August 29, 2008

ADDENDUM NO. 2
FOR THE
WILLOWS SENIOR CENTER FIRE DAMAGE REPAIR

Notice is hereby given that the following revisions, clarification, additions and/or deletions are hereby made of, and incorporated into plans and specifications for the **WILLOWS SENIOR CENTER FIRE DAMAGE REPAIR.**

WINDOW HEAD - JAMB SIM.
3"=1'-0"

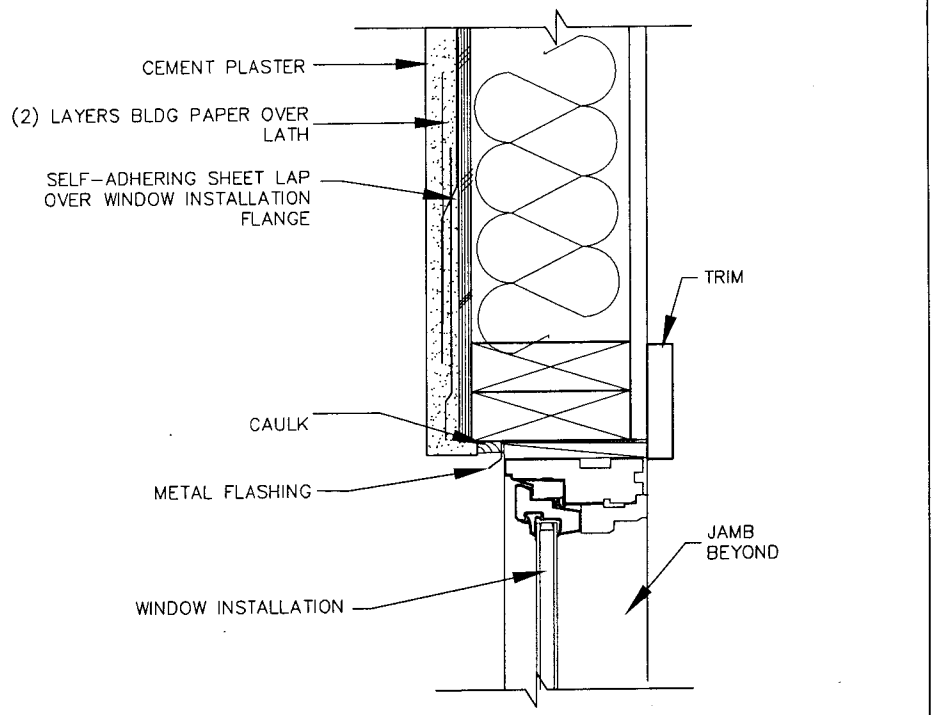
Question #14:
On the window schedule, please provide sill, head and details for room 102. Also show Plaster and flashing detail for the waterproofing.
Answer #14:
Add window head and sill detail. See drawing clarification #4 below.

4. **Clarification** on sheet A-7 below:
   - **Change** door schedule to indicate hollow metal frame for new doors. See attached drawing **AD-2.7**
   - **Change** Food Storage 110 door to 3 feet 6 inches. See attached drawing **AD-2.7**
   - **Change** head & jamb detail in interior door schedule to indicate "7/A-8". See attached drawing **AD-2.7**
   - **Change** wall base at Food Storage 110 to cove base in finish schedule. See attached drawing **AD-2.7**
   - **Revise** finish notes. See attached drawing **AD-2.7**
   - **Add** window head detail. See attached drawing **AD-2.8**
   - **Add** window sill detail. See attached drawing **AD-2.9**

DOOR HEAD - JAMB SIM.

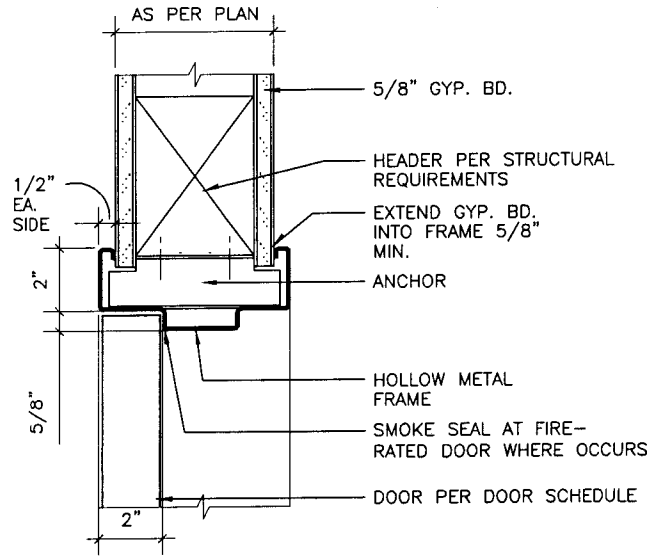
Question #12:
Drawing A-7: The interior door schedule references head and jamb detail 1/A-11. This detail does not exist. See detail 7/A-8. Please provide dimensions for jambs and trim?
Answer #12:
Revise head detail. See drawing clarifications #4 & #5 below.

5. **Clarification** on sheet A-9 below:
   - **Change** door head detail to show hollow metal frame. See attached drawing **AD-2.10**

PROJECT. NO.	TITLE	SCALE	SHEET NO.
07114	Addendum 2	1/4"=1'-0"	
REFERENCE SHEET: M-2	PROJECT Willows Sr. Cntr. Fire Damage Repair	DATE 27 Aug '08	MAD-2.2

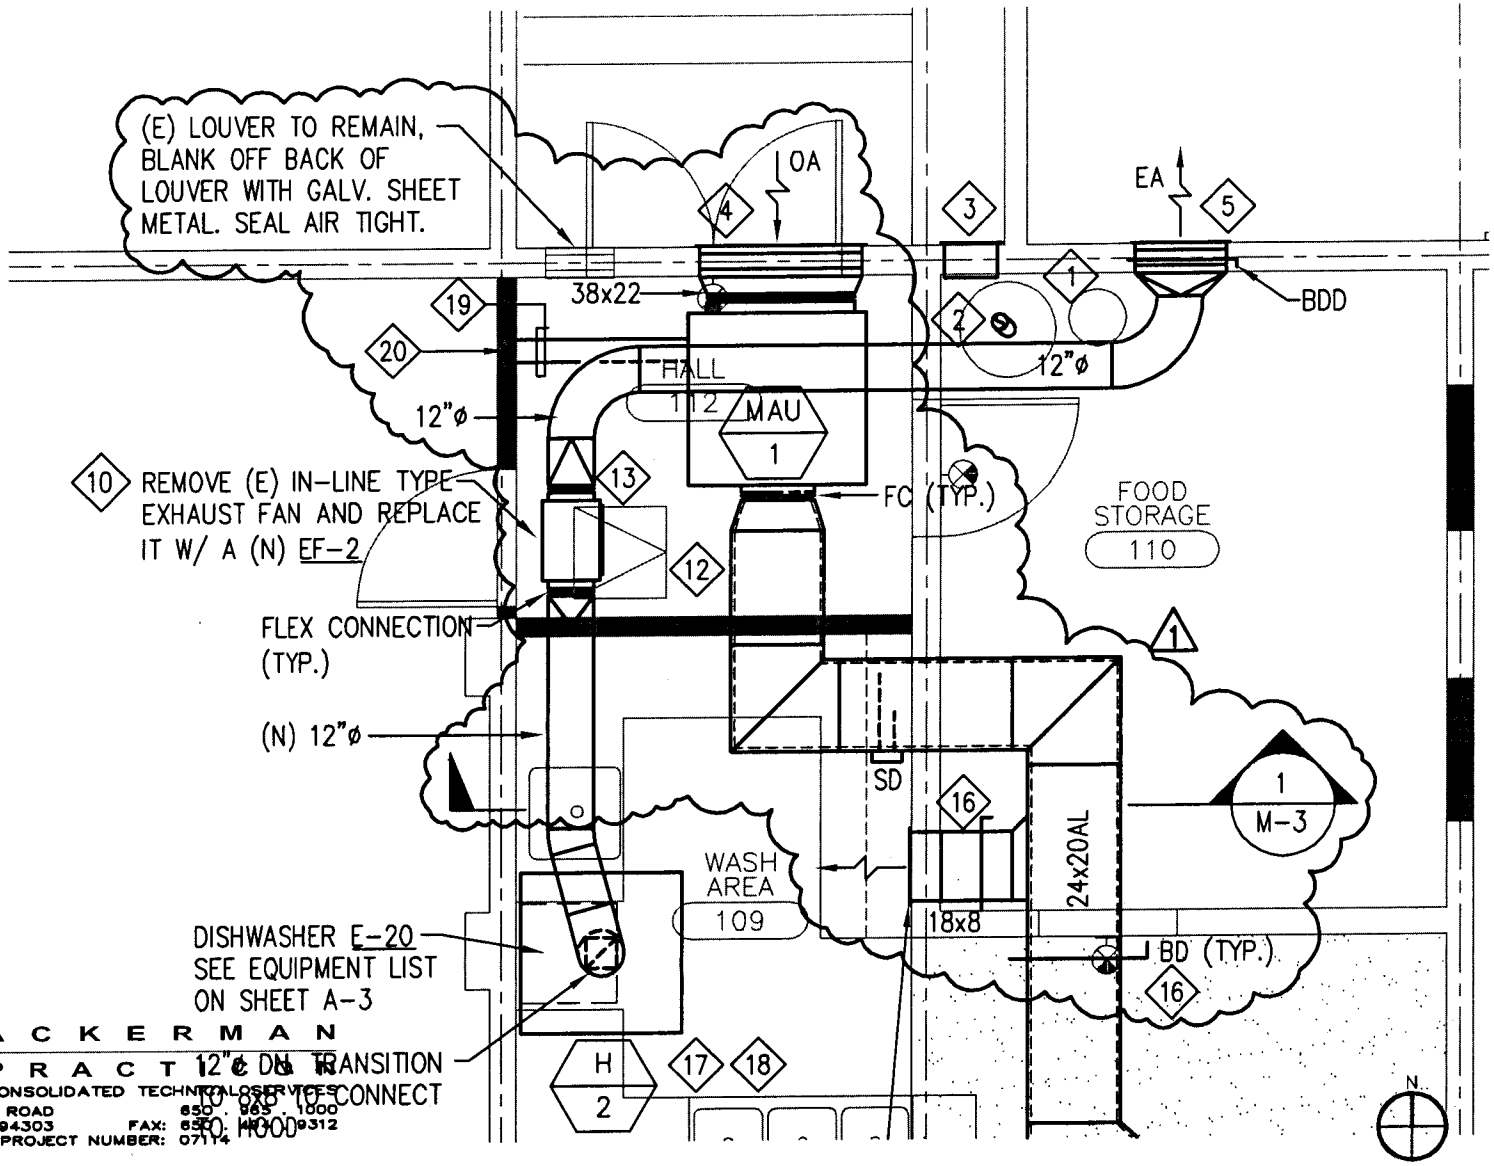
Question #25:
Dwg M-2: MAU 1 and the dishwasher exhaust conflict at line 2 due to the fact that the existing ceiling is 10 inches higher than shown not enough vertical room in the attic for the ductwork as drawn. Dishwasher exhaust over the Mau duct is large than the existing space.
Answer #25:
Equipment and ductwork layout have been revised. See MAD-2.2 & MAD-2.4.

7. **Clarification** on sheet M-2 below. (See attached **MAD-2.2**)
   - **Revise** location and layout for **MAD-1** and **EF-2.**

PROJECT. NO.	TITLE	SCALE	SHEET NO.
07114	Addendum 2	1/4"=1'-0"	
REFERENCE SHEET: M-2	PROJECT Willows Sr. Cntr. Fire Damage Repair	DATE 27 Aug '08	MAD-2.3

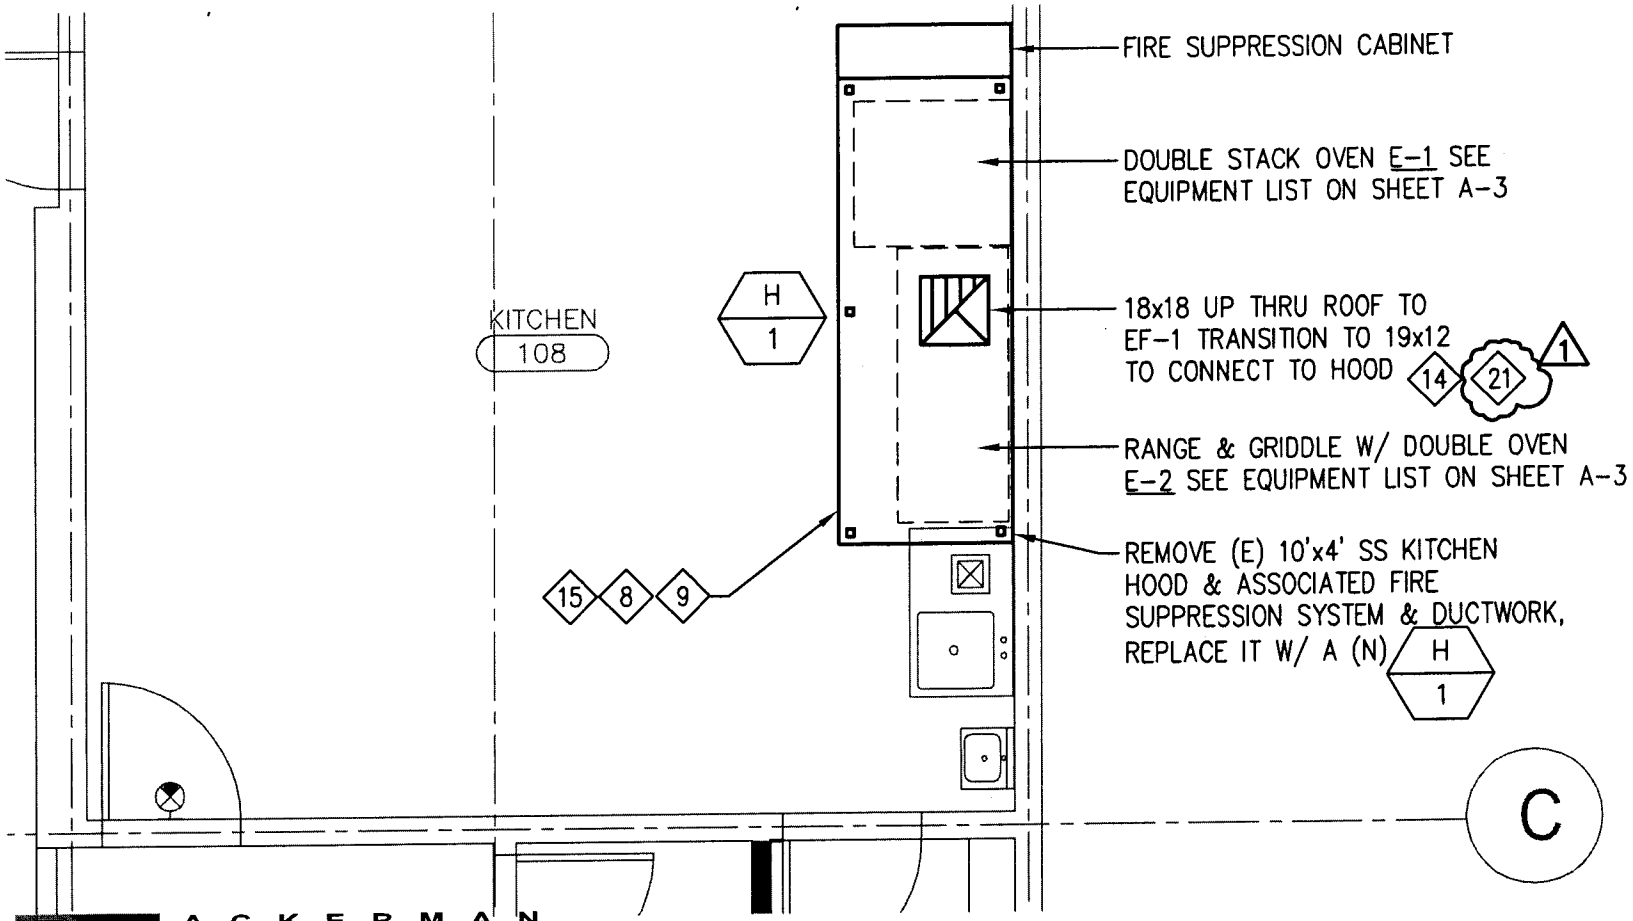
Question #27:
Dwg M-2: Please confirm detail 3 is correct as drawn. I believe this needs a 3 inch airspace and sheetrock or 3M fire-rated assembly. There are no structural details for framing this opening.
Answer #27:
See added Note #21. See MAD-2.1 & MAD -2.3. It is existing condition; we do not have existing structural drawings. Condition to be field verified after exiting hood is removed.

8. **Clarification** on sheet M-2 below. (See attached **MAD-2.3**)
   - **Add** note 21 to exhaust duct for hood **H-1.**

7 WH COMBUSTION AIR OPENINGS DETAIL

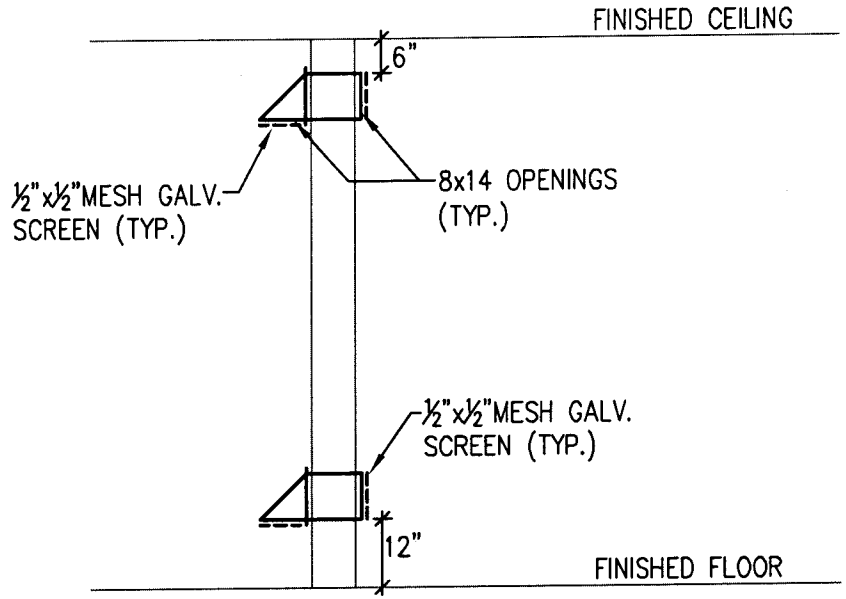
Question #28:
Dwg M-3: Please provide waterproof details for combustion air on detail 7. Will this have a surface mounted flange or will plaster be removed with J metal and caulking details.
Answer #28:
See revised Detail 7/M-3 on MAD-2.5

10. **Clarification** on sheet M-3. (See **MAD-2.5**)
    - **Add** note to Detail #7.

NOTE: SECURE EACH CORNER OF THE WALL VENT TO THE WALL FRAME. USE WALL ANCHOR IF REQUIRED. SEAL WALL PENETRATION WEATHER TIGHT USING OUTDOOR SILICONE SEALANT. 1

PROJECT. NO.	TITLE	SCALE	SHEET NO.
07114	Addendum 2	1/8"=1'-0"	EAD-3.2
REFERENCE SHEET: E3	PROJECT Willows Sr. Cntr. Fire Damage Repair	DATE 27 Aug '08

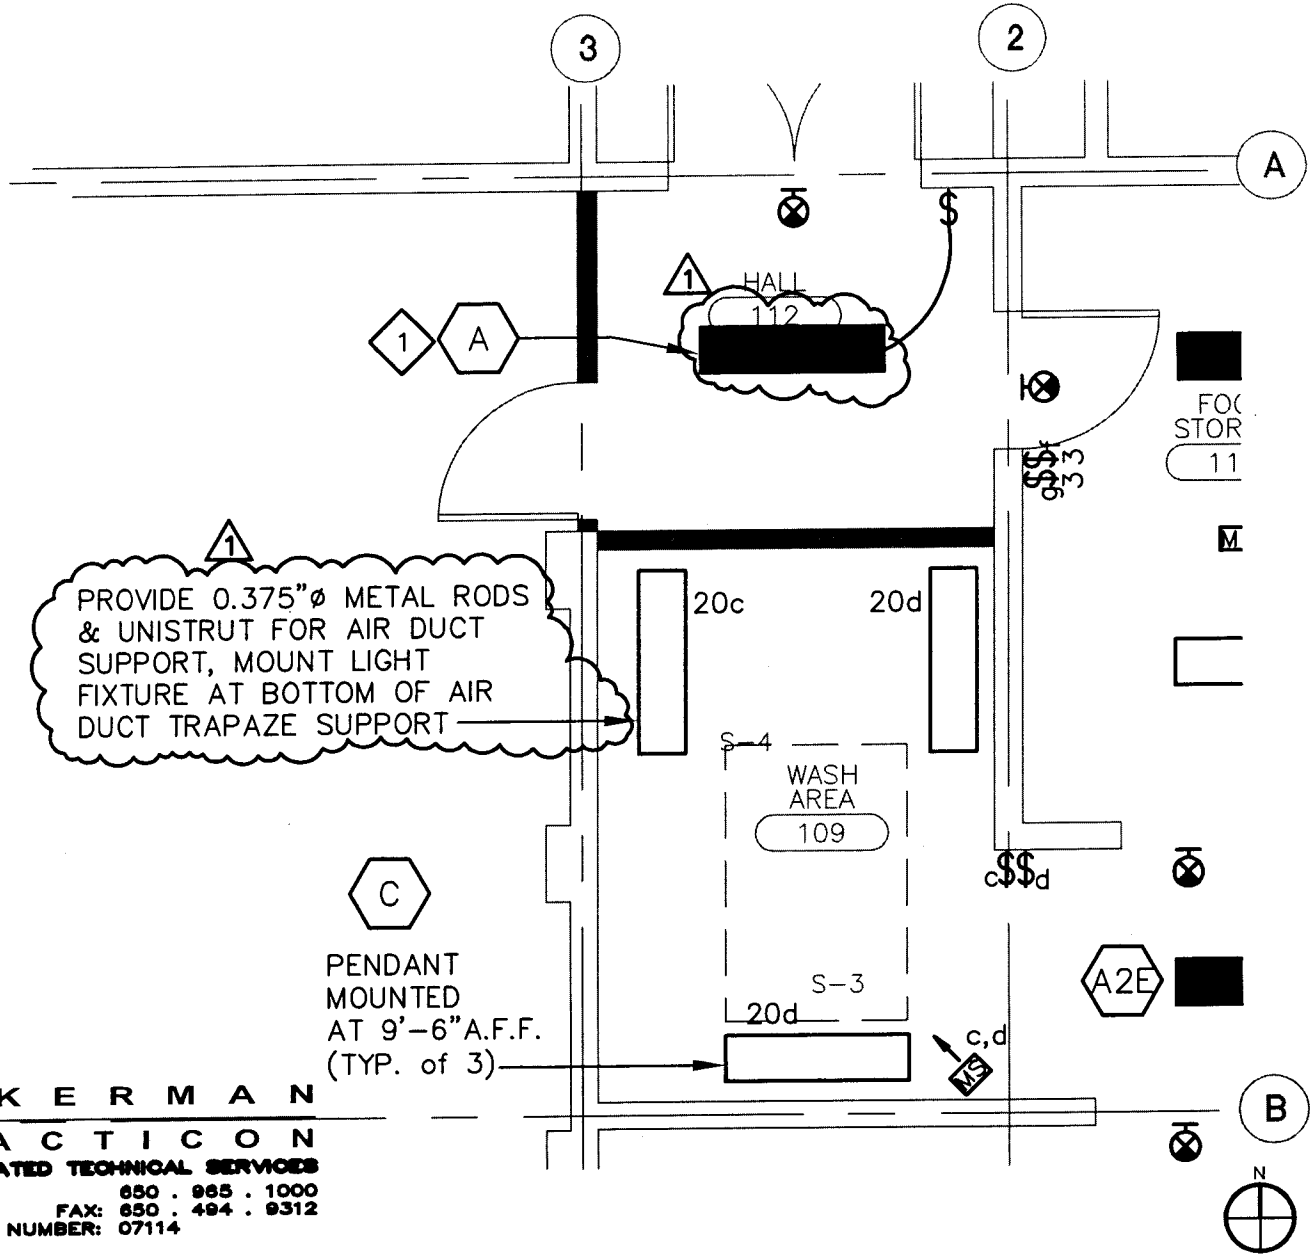
Question #31:
Dwg E-3: Fixture A not fit between existing framing. No standard framing details are on the drawing
Answer #31:
Change to 1'x 4' fixture.

13. **Clarification** on sheet E-3. (See attached **EAD-3.2**)
    - **Revise** type "A" fixture's dimension in lighting plan.
    - **Add** note for one type "C" fixture in wash area 109.
